Plumbing and drainage Part 1: Water services

Amendment No. 1

Correction amendment

Figure 4.6.3.1(A) — Typical minimum protection for filling tanker trucks

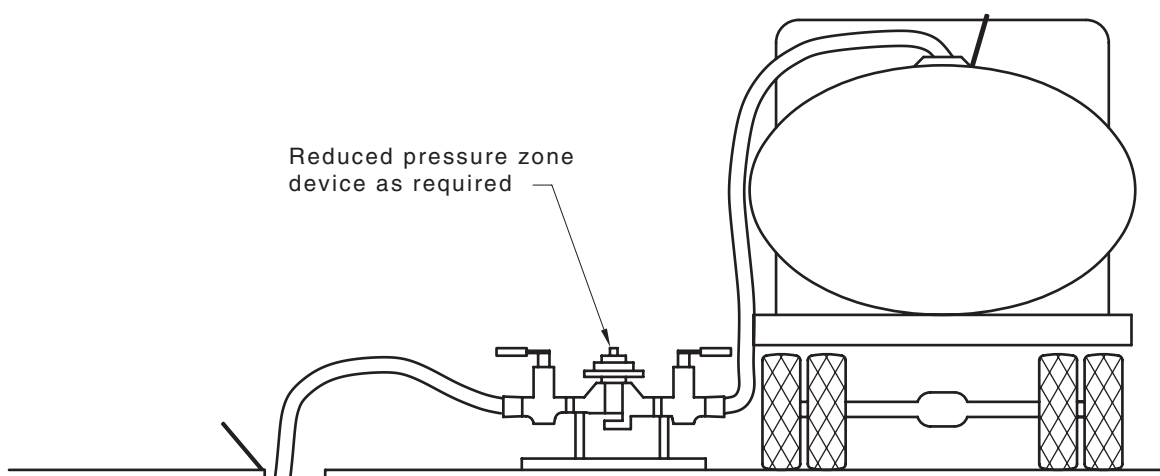
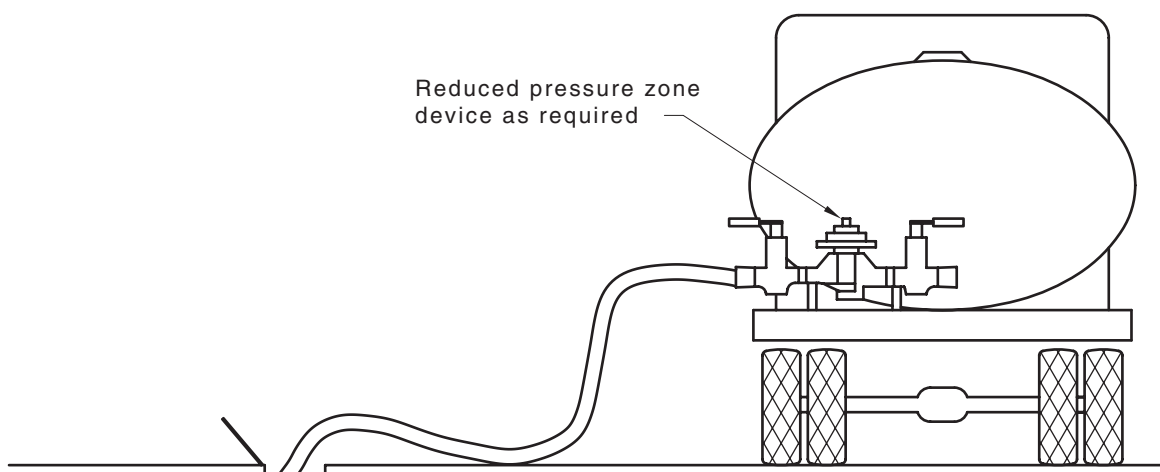
Element	Instruction/New text
CI 2.2 Note 2	Delete "G13 Foul Water" and <i>replace</i> with "G12 Water Supplies"
CI 4.6.3.1	After first paragraph, <i>add</i> the following: NOTE: See Figures 4.6.3.1(A) to 4.6.3.1(G) for typical installations for testable and non-testable backflow prevention devices.
Figures 4.6.3.1(A) to (G) (new)	<i>Add</i> the following figures:
